TOWN OF NEWBURGH PLANNING BOARD **TECHNICAL REVIEW COMMENTS**

1 POWELTON AVENUE

2015-19

11 MARCH 2016

SP-1R

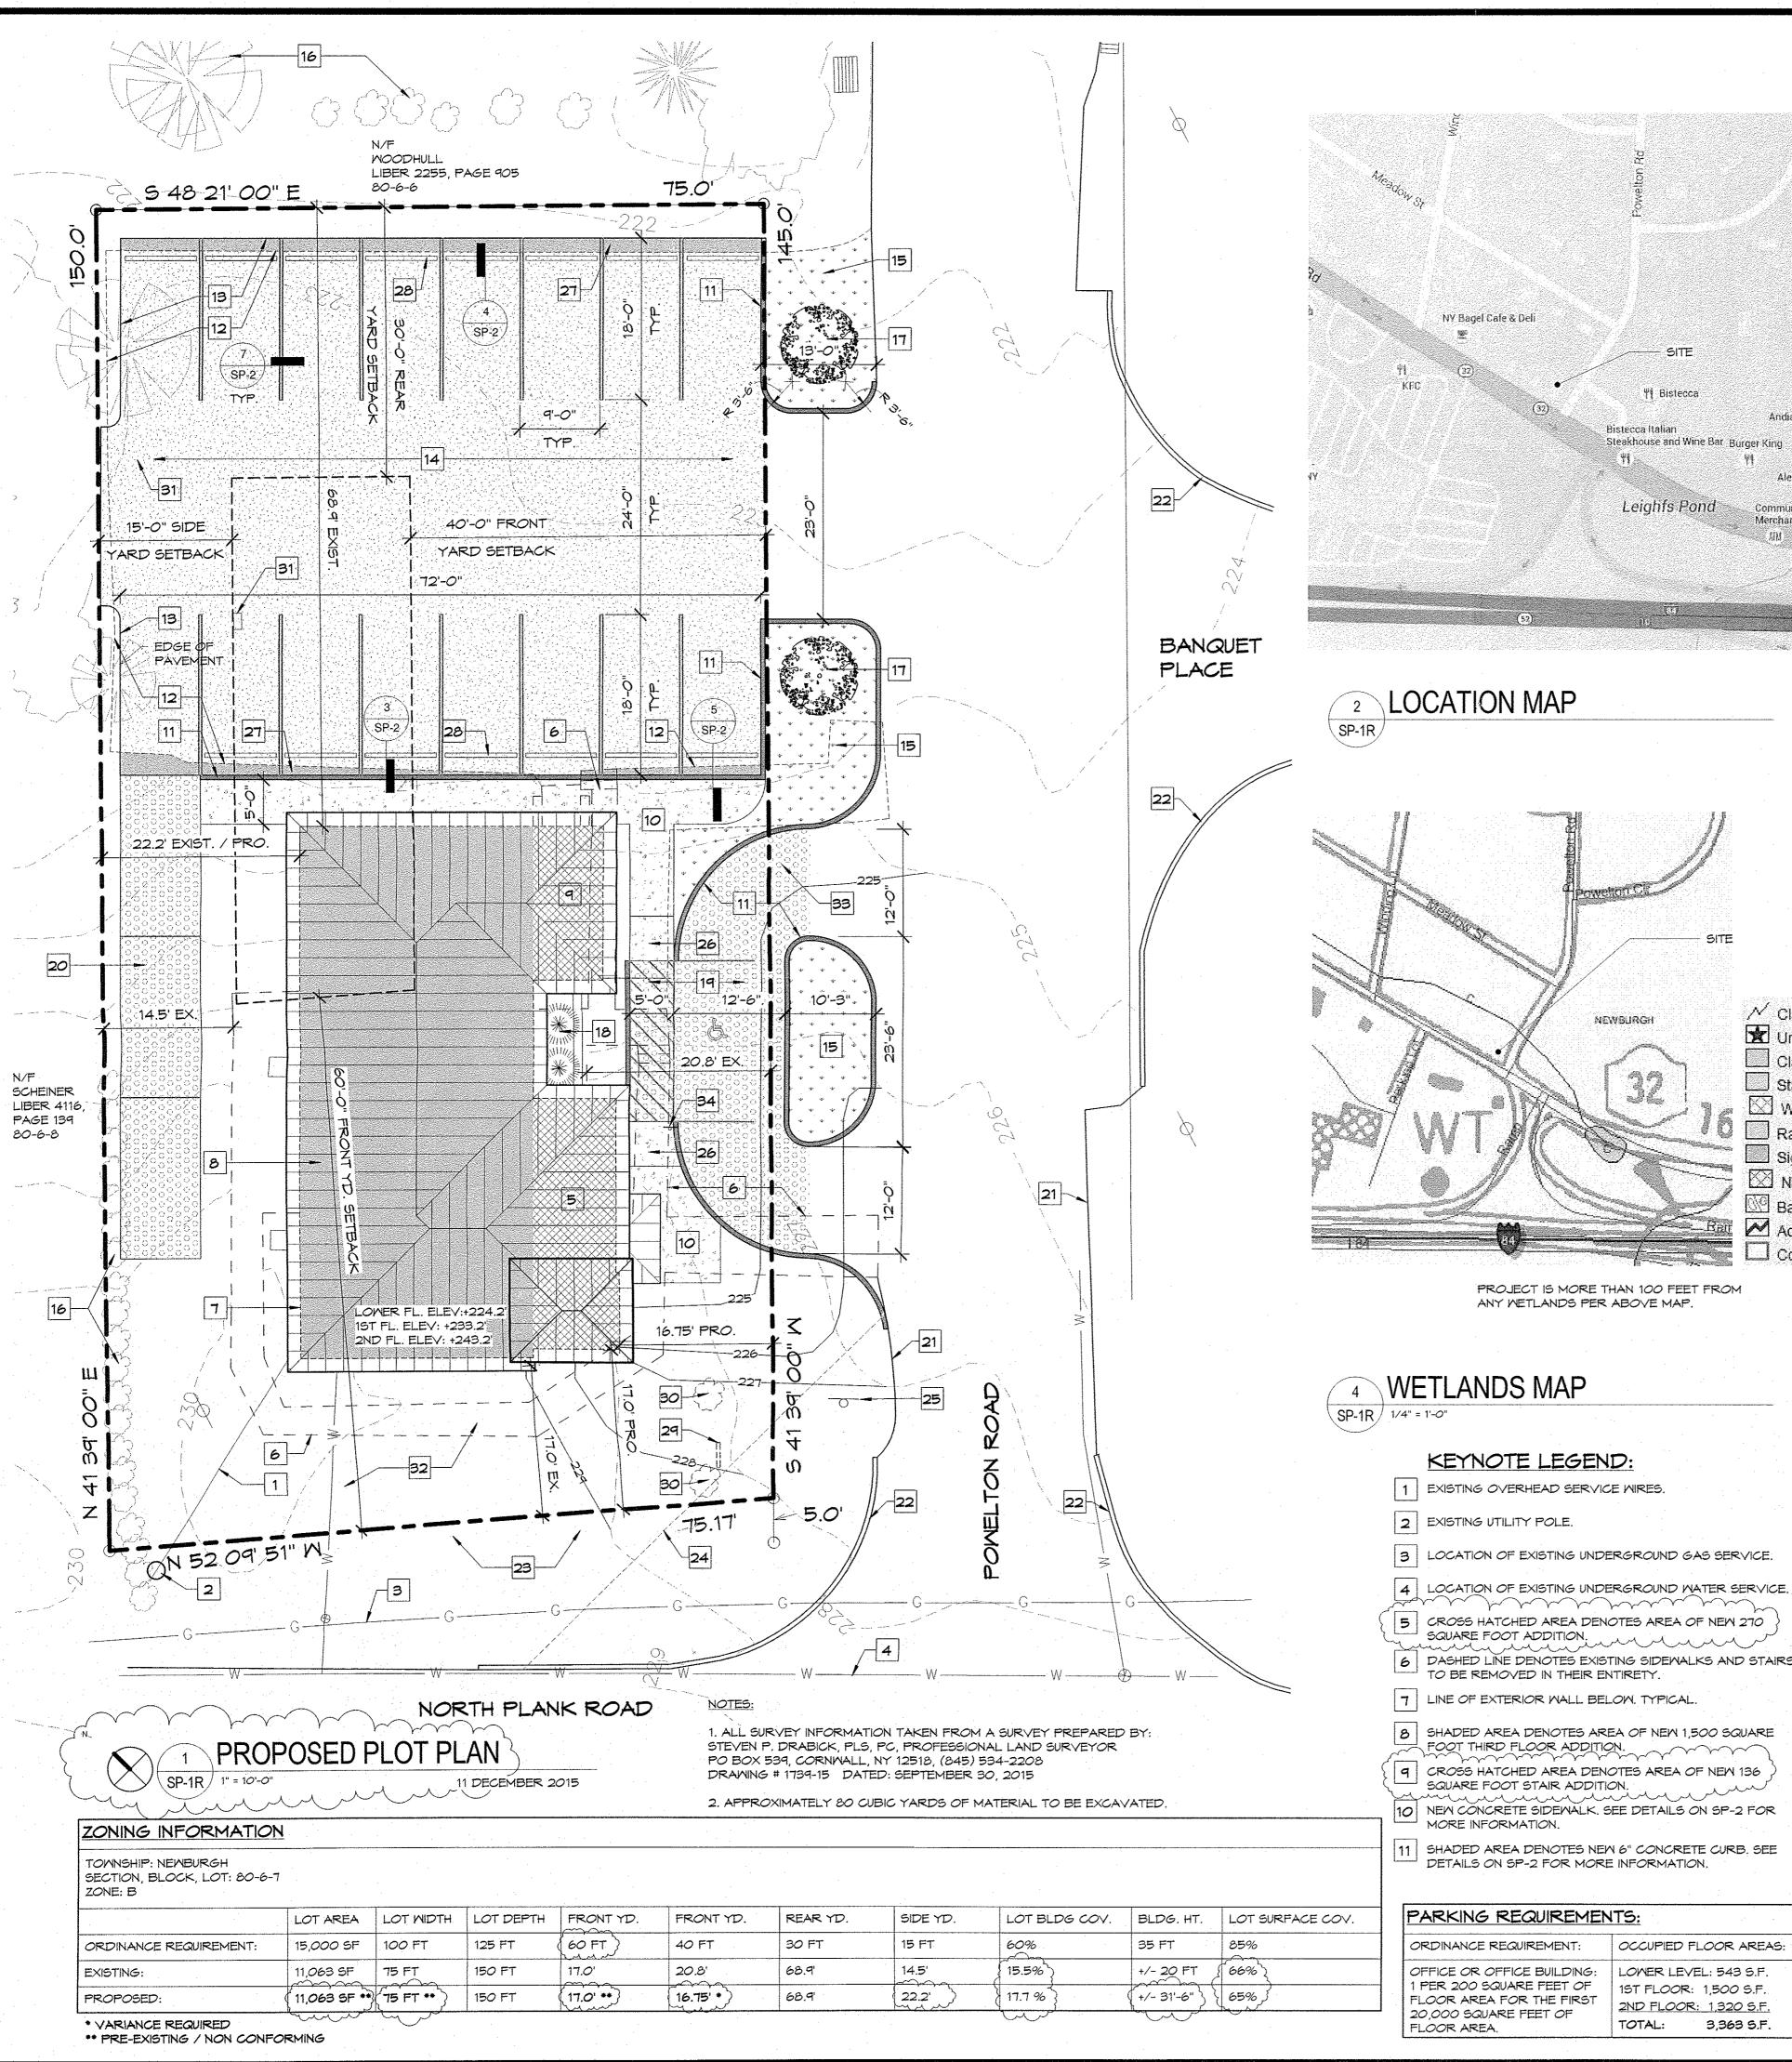
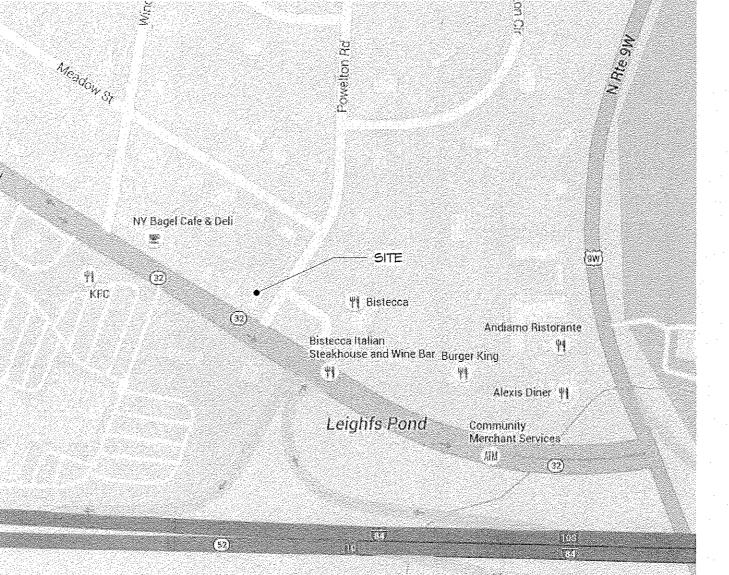
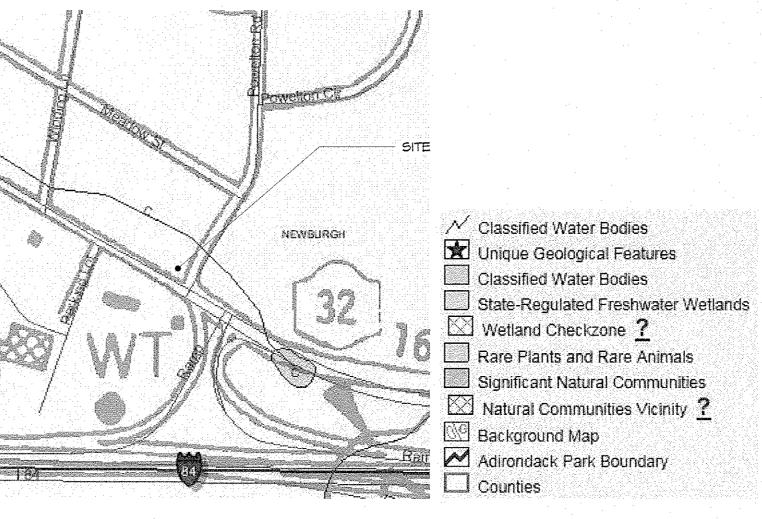
- 5. The Planning Boards attention is called to Item # 20 on sheet SP-1R identifying employee parking spaces to the rear of the structure with limited access. Materials utilized for these spaces should be identified on the plans.

- 6. The Applicant's Representative will be requested to discuss how the 3 handicapped parking spots identified as Item #19 on sheet SP-1R, will function. A vehicle parked in these spaces will completely block access to any other vehicle entering or exiting. Curb located behind the parking would further restrict any access to these spots.
